January 22, 2026

NEX-2300100.00

SUBJECT: Response to Comments  
Notice of Intent: Replacement of Brandy Brow Culvert over East Meadow River  
Haverhill, Massachusetts  
DEP File No. 033-1591

## **Supplemental RFA and BLSF Impact Construction Plan (Sheet 4)**

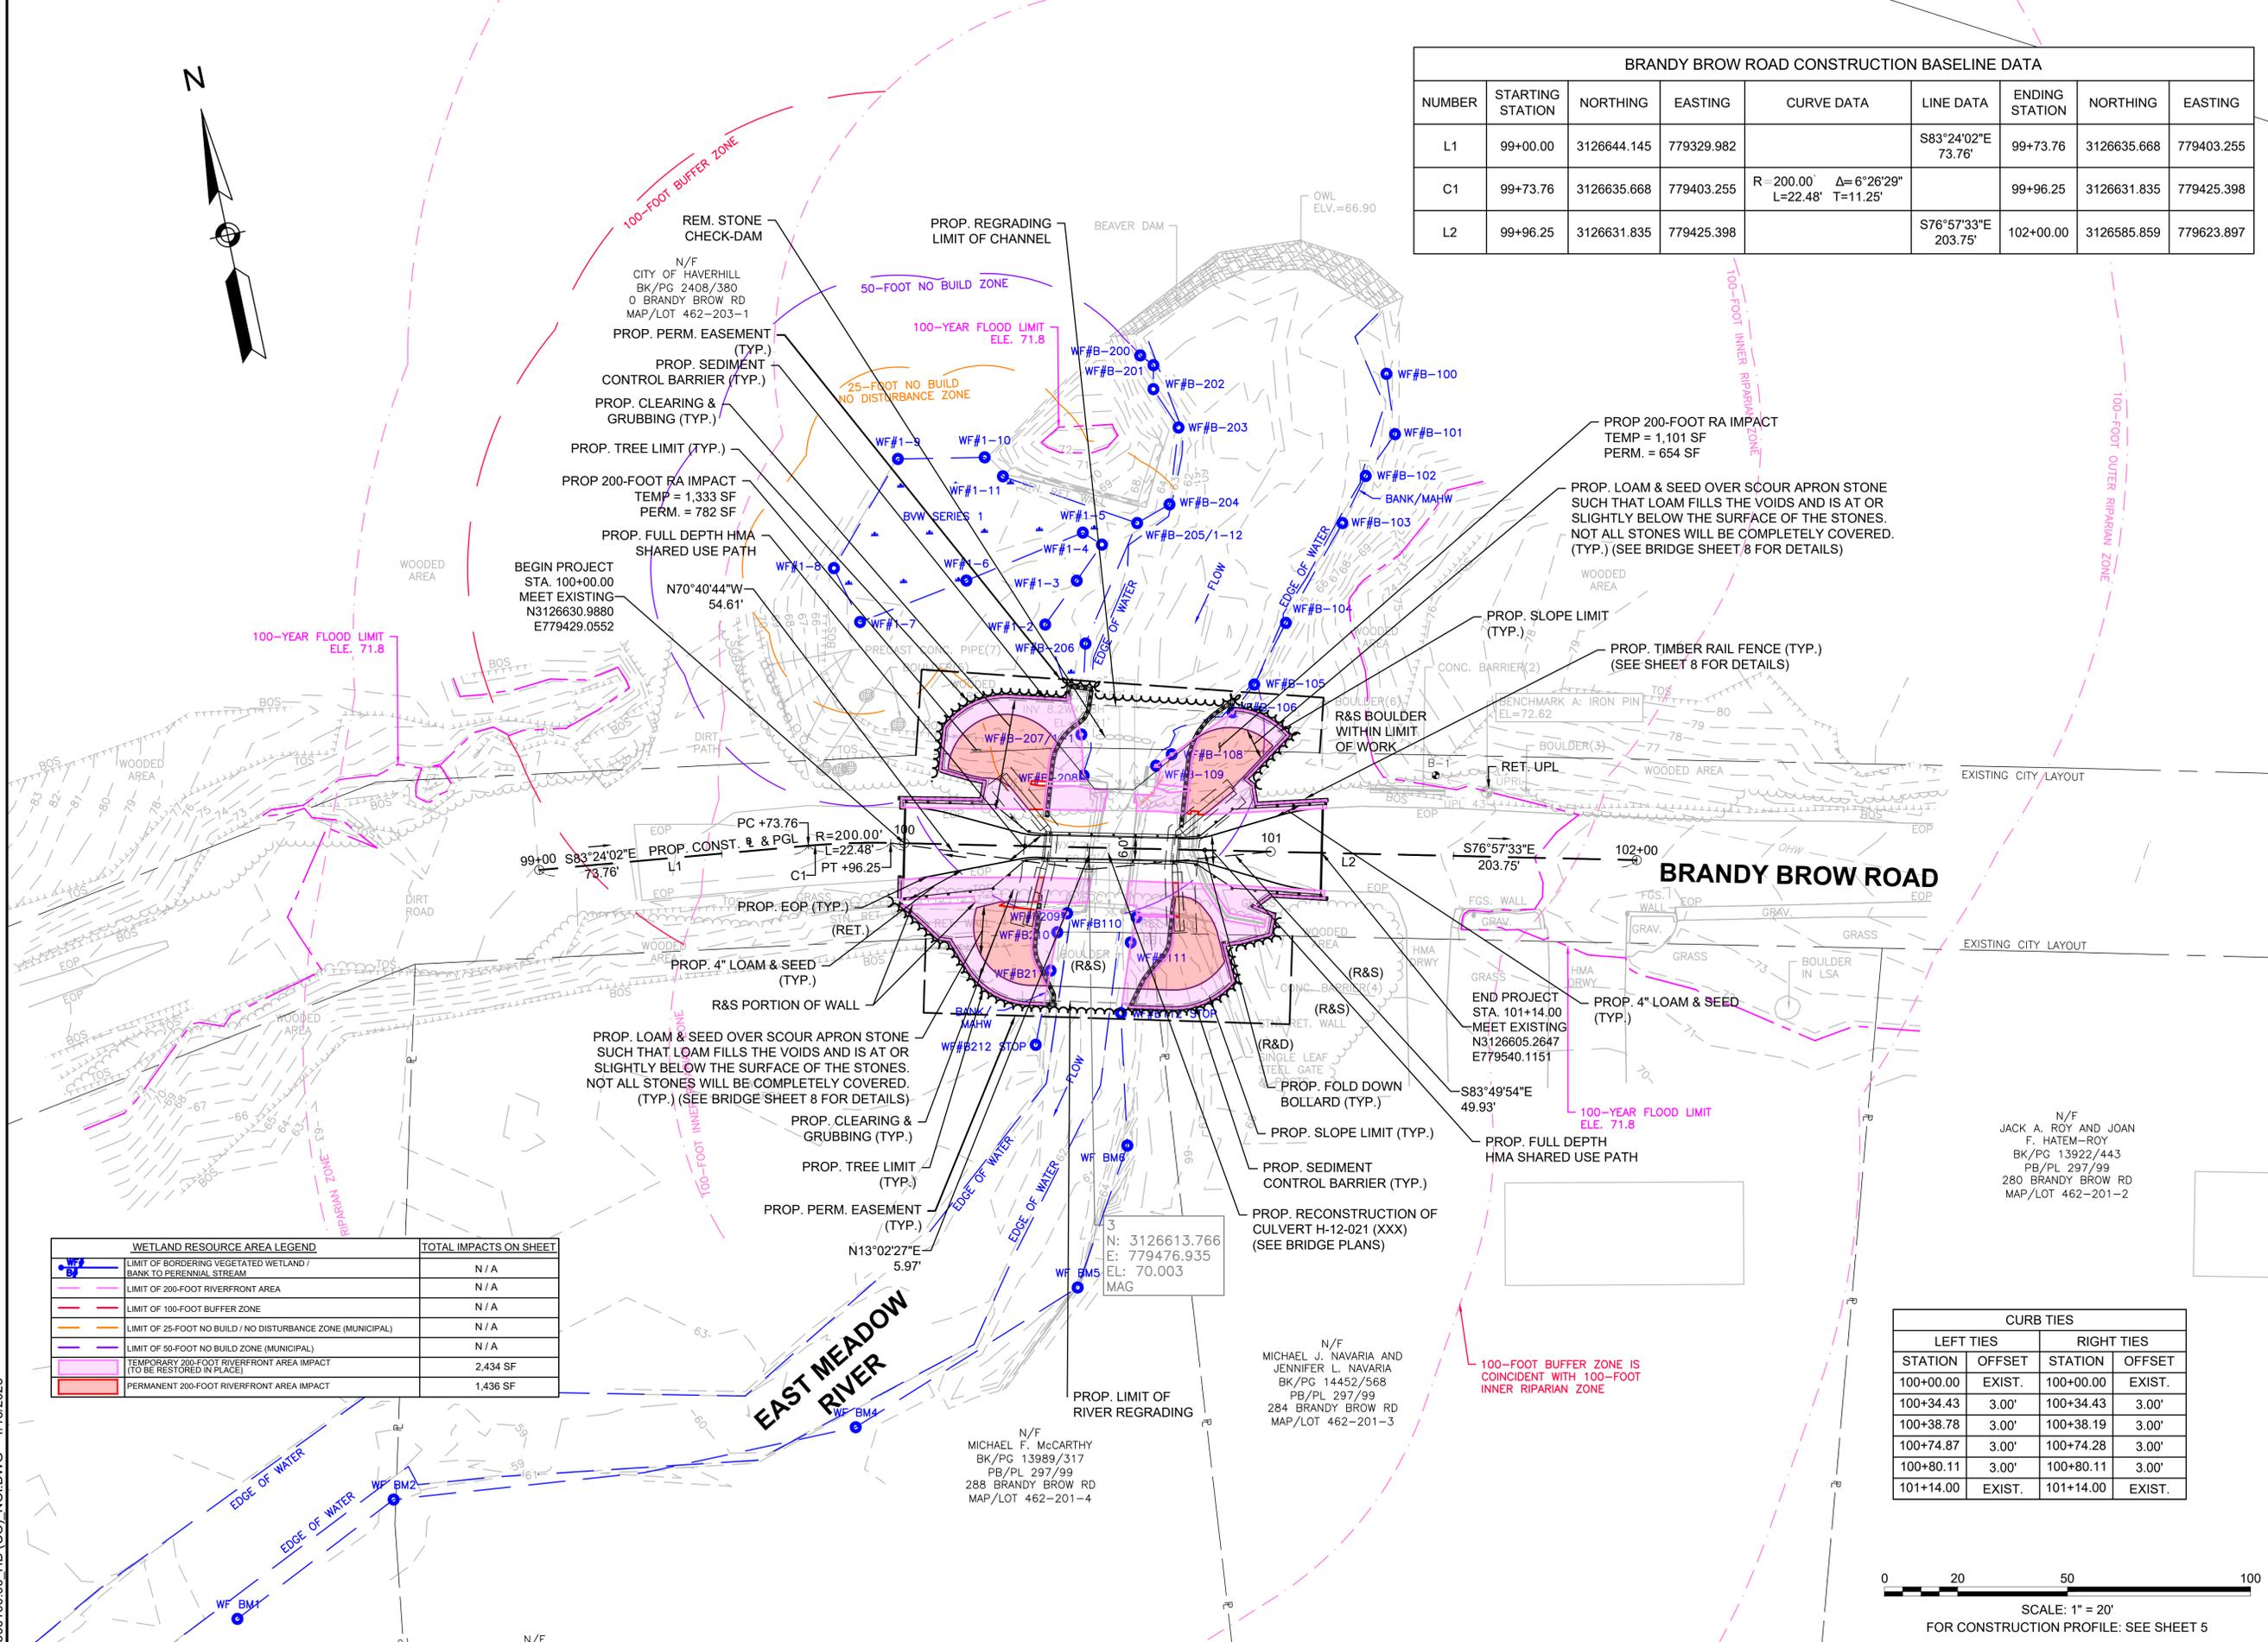
**Comment 4:** *The NOI proposes to temporarily alter BVW, LUW, BLSF and RFA and permanently alter Bank, BLSF and RFA; however, the sites do not show any of this. Therefore, the site plans should be revised to show where all wetland resource area alteration is occurring, differentiating the alteration that is temporary versus permanent, and those wetland resource areas that are being restored in-kind or compensated.*

**Response 4:** GPI would like to confirm whether MassDEP feels that the project plans provided electronically on January 8, 2026 accurately depict the proposed alteration as outlined in the comment above. Sheet 4 of the plans includes the wetland resource boundaries and impacts in color as well as a legend identifying the line, hatch, and colors as well as the proposed resource area alteration totals. GPI has provided a supplemental plan sheet identifying work within RFA and BLSF with this letter as an enclosure. Please note that work within BLSF is coincident to work within RFA.

## **Revised Notice of Intent Plan Set**

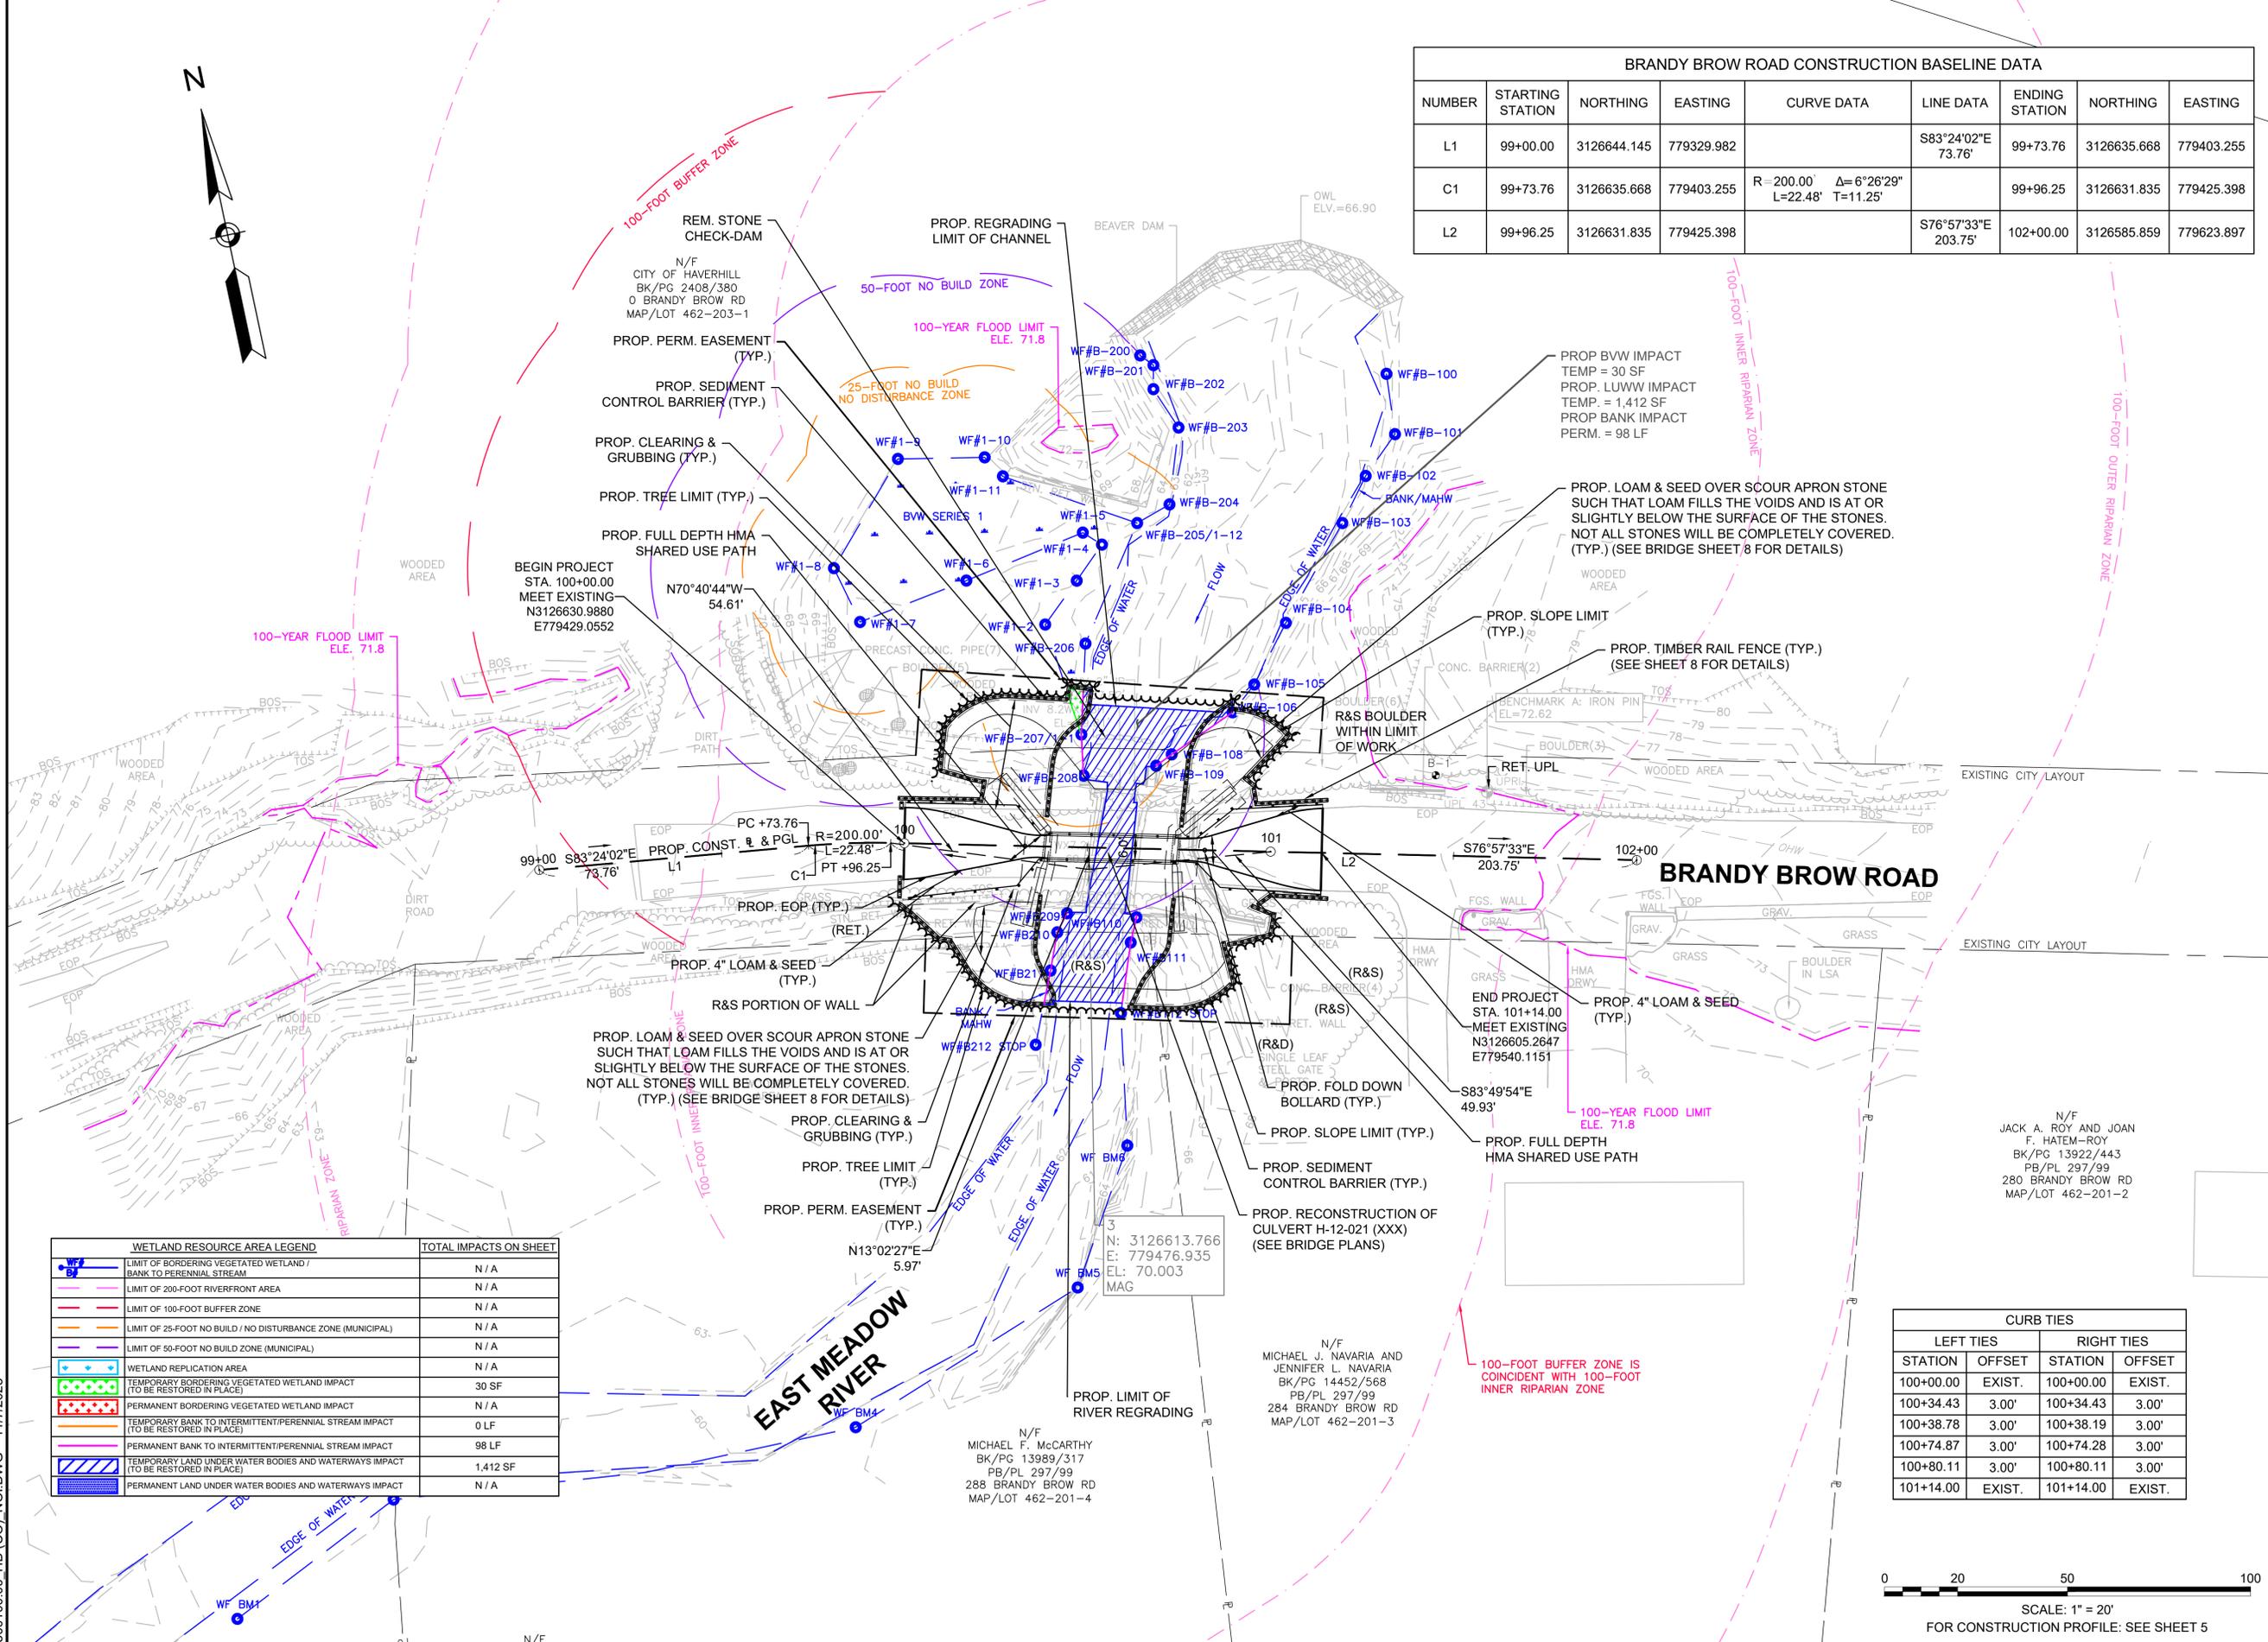
**Comment 6:** *The site plans and profiles should also be revised to show the dimension(s) of the low-flow channel along with STA within the thalweg if it will vary in width.*

**Response 6:** The Notice of Intent Plans provided to MassDEP NERO on January 8, 2026 detail the low-flow channel on sheets 6, 9, 12, 14, 16, and 17 at elevation 60'. The low-flow channel as depicted in the originally submitted plans showed two areas of low flow. This has been revised to combine both the grades at elevation 60' and provide a longer, continuous channel that passes beneath the proposed culvert. The low-flow channel will act as a pool, providing aquatic organisms a suitable habitat that maintains natural water depth beneath the culvert. A revised plan set is included as an enclosure with this letter.
